SIGNAL GENERAL NOTES

DESIGNER JMW
REVIEWER RMM 07-02-26
PROJECT ID 124366
SHEET P.3 TOTAL 21

ATB-45/7-19.93/28.84

ADDED

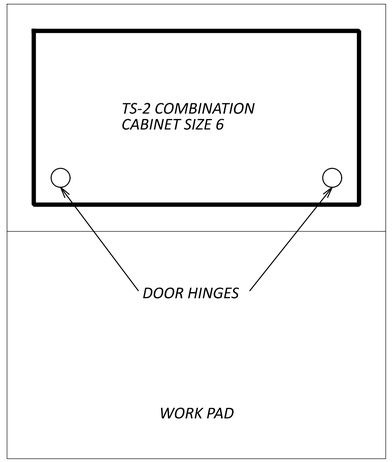
633 UNINTERRUPTIBLE POWER SUPPLY (UPS), 1000 WATT, AS PER PLAN

IN ADDITION TO THE REQUIREMENTS OF C&MS 633 AND 733, POLE ATTACHMENT HARDWARE WILL BE INCLUDED FOR POLE-MOUNTED CABINETS, AND A CABINET RISER (8-INCH MINIMUM) AND ANCHOR BOLTS WILL BE PROVIDED FOR BASE-MOUNTED CABINETS. BEFORE PERFORMING THE WORK, THE CONTRACTOR, THE DISTRICT TRAFFIC ENGINEER AND THE PROJECT ENGINEER WILL PERFORM A SITE INSPECTION TO ESTABLISH THE LOCATION OF THE UPS CABINET AND FOUNDATION.

THE UPS CABINET SHALL INCLUDE A GENERATOR POWER PANEL WITH A HEAVY-DUTY POWER RELAY VERSUS THE LINE VOLTAGE GENERATOR SWITCH. THE GENERATOR INLET SHALL BE A RECESSED PANEL WITH A DOOR THAT IS FLUSH WITH THE EXTERNAL SIDE OF THE UPS CABINET. IT SHALL INCLUDE A RECESSED PLUG, AUTOMATIC TRANSFER SWITCH & A DOOR THAT SECURELY CLOSES OVER THE POWER CORD.

THE CABINET SHALL HAVE SLIDING DRAWERS TO ALLOW EASY REMOVAL AND INSTALLATION OF BATTERIES AND ACCESS TO THE CABLE IN THE BOTTOM OF THE CABINET.

THE CABINET SHALL HAVE A DOOR STOP MECHANISM & THERMOSTATICALLY CONTROLLED FAN. ADDITIONALLY, THE CABINET SHALL BE BUILT WITH ALL BATTERIES ALWAYS BELOW THE INVERTER TO AVOID POTENTIAL FURTHER BATTERY LEAKAGE ISSUES.

THE CABINET SHALL INCLUDE A BATTERY BALANCING DEVICE THAT REGULATES THE BATTERIES AND OPTIMIZES PERFORMANCE.

THE UPS FURNISHED SHALL BE LISTED ON THE TRAFFIC AUTHORIZED PRODUCTS (TAP) LIST.

AFTER FOUR (4) HOURS OF BATTERY RUNTIME, THE SYSTEM SHALL BE PROGRAMMED TO SWITCH THE INTERSECTION FROM FULL OPERATION TO CONTROLLER AUTOMATIC FLASH OPERATION THROUGH THE MONITOR. THE CONTROLLER SHALL BE PROGRAMMED SO THAT FLASH OPERATION SHALL BEGIN ONCE THE INTERSECTION RUNS MINOR STREET GREEN (TYP. PH. 4 & 8), ALL-RED CLEARANCE, AND THEN FLASH OPERATION.

THE UPS OUTPUT NOTIFICATIONS FOR ON BATTERY, BATTERY 2-HOUR TIMER & LOW BATTERY SHALL BE WIRED INTO THE TRAFFIC SIGNAL CABINET BACK PANEL WITH SPECIAL STATUS ALARMS FOR EACH OUTPUT INTO THE SIGNAL CONTROLLER.

THIS ITEM SHALL INCLUDE A RED LED STATUS INDICATOR LAMP TO ALLOW MAINTENANCE PERSONNEL AND LAW ENFORCEMENT TO QUICKLY ASSESS WHETHER A TRAFFIC SIGNAL CABINET IS BEING POWERED BY A UPS. THE LED HOUSING SHALL BE NEMA 4X, IP65 OR IP66, RATED FOR OUTDOOR USE AND BE TAMPER/ SHATTER RESISTANT. IT SHALL BE A DOMED ENCLOSURE CONTAINING A RED LENS WITH LED THAT IS VISIBLE FROM 100 FOOT MINIMUM. THE ENCLOSURE AND LED MODULE SHOULD BE PLACED ON THE SIDE OF THE UPS CABINET FACING TOWARDS THE MAINLINE ROADWAY AND SEALED FROM WATER INTRUSION. IT SHOULD BE WIRED USING MINIMUM 20GA STRANDED, INSULATED HOOKUP WIRE TO THE STATUS RELAY OUTPUTS OF THE UPS. THE WIRES SHALL BE TERMINATED BY LUGS AT THE DISPLAY END AND PERMANENTLY LABELED "BACKUP POWER STATUS DISPLAY," WITH WIRE POLARITY INDICATED. THE RED LED SHALL ONLY ILLUMINATE TO INDICATE THE CABINET IS OPERATING UNDER UPS BACKUP POWER (THE "BACKUP" OPERATING CONDITION). THIS ITEM INCLUDES PROGRAMMING THE UPS STATUS RELAY OUTPUTS TO PRODUCE THE LAMP STATUS DISPLAYS. THESE STATUS DISPLAYS WILL BE SOLID 100% DUTY CYCLE (NOT FLASHING) DISPLAYS. THE OPERATING VOLTAGE OF THE LED LAMP SHALL BE 120V AC UNLESS OTHERWISE INDICATED.

SIGNAL DETAILS
ATB IR 90 WB AT SR 45

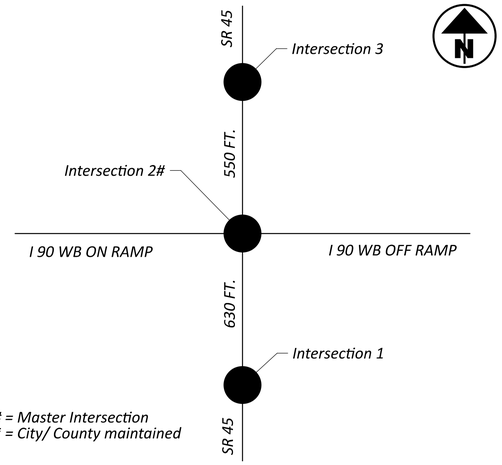
TEM Form 496-16 Field Wiring Hook-up Chart			
SIGNAL HEAD	INDICATION	FIELD TERMINAL	FLASH
2A (NB)	R	Φ2 R	R
	Y	Φ2 Y	
	G	Φ2 G	
	-	-	
	-	-	
5A (NB LT)	R	Φ2 R	R
	Y	Φ2 Y	
	G	Φ2 G	
	<--Y---	Φ5 Y	
	<--G---	Φ5 G	
4A,4B (WB)	R	Φ4 R	R
	Y	Φ4 Y	
	G	Φ4 G	
	-	-	
	-	-	
6A,6B (SB)	R	Φ6 R	R
	Y	Φ6 Y	
	G	Φ6 G	
	-	-	
	-	-

SIGNAL DETAILS
ATB IR 90 WB AT SR 7

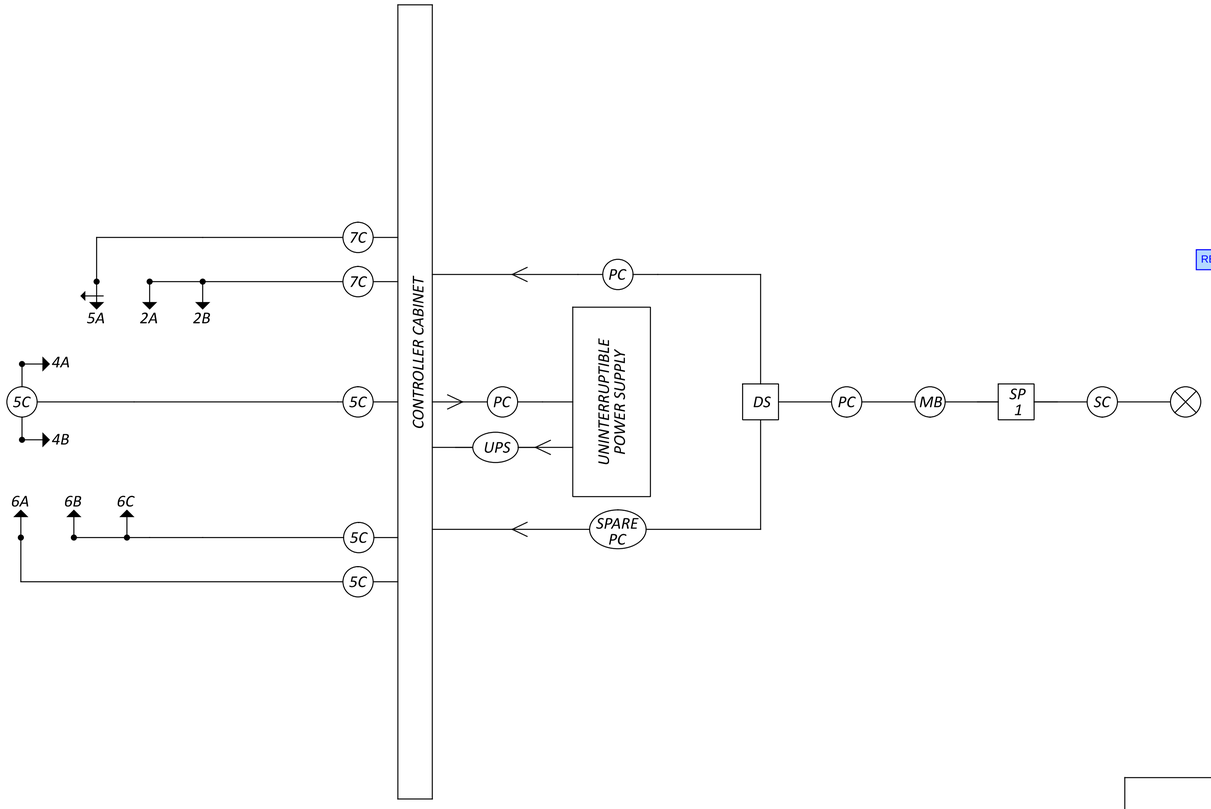
REVISED

TEM Form 496-16 Field Wiring Hook-up Chart			
SIGNAL HEAD	INDICATION	FIELD TERMINAL	FLASH
2A,2B (NB)	R	Φ2 R	R
	Y	Φ2 Y	
	G	Φ2 G	
	-	-	
	-	-	
5A (NB LT)	R	Φ2 R	R
	Y	Φ2 Y	
	G	Φ2 G	
	<--Y---	Φ5 Y	
	<--G---	Φ5 G	
4A,4B (WB)	R	Φ4 R	R
	Y	Φ4 Y	
	G	Φ4 G	
	-	-	
	-	-	
6A,6B,6C (SB)	R	Φ6 R	R
	Y	Φ6 Y	
	G	Φ6 G	
	-	-	
	-	-

SIGNAL DETAILS
ATB IR 90 EB AT SR 7

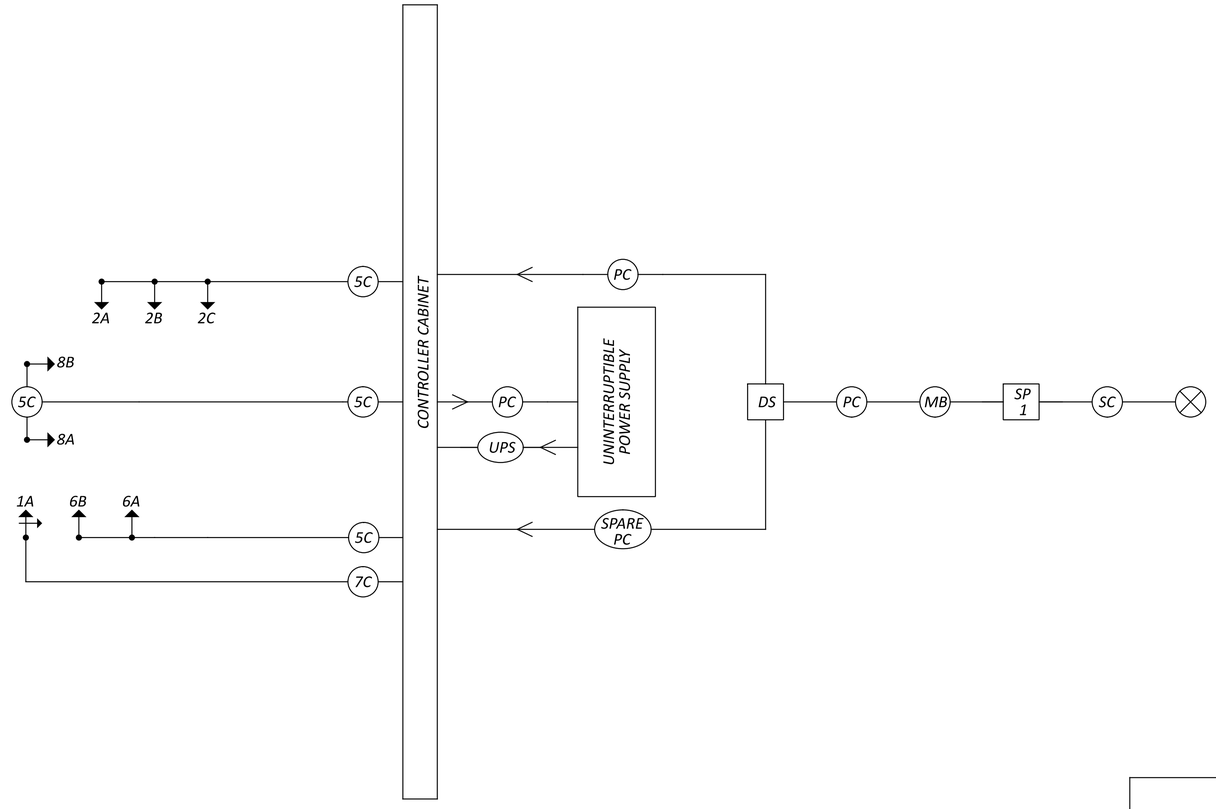
REVISED

TEM Form 496-16 Field Wiring Hook-up Chart			
SIGNAL HEAD	INDICATION	FIELD TERMINAL	FLASH
2A,2B,2C (NB)	R	Φ2 R	R
	Y	Φ2 Y	
	G	Φ2 G	
	-	-	
	-	-	
6A,6B (SB)	R	Φ4 R	R
	Y	Φ4 Y	
	G	Φ4 G	
	-	-	
	-	-	
1A (SB LT)	R	Φ6 R	R
	Y	Φ6 Y	
	G	Φ6 G	
	<--Y---	Φ1 Y	
	<--G---	Φ1 G	
8A,8B (EB)	R	Φ6 R	R
	Y	Φ6 Y	
	G	Φ6 G	
	-	-	
	-	-
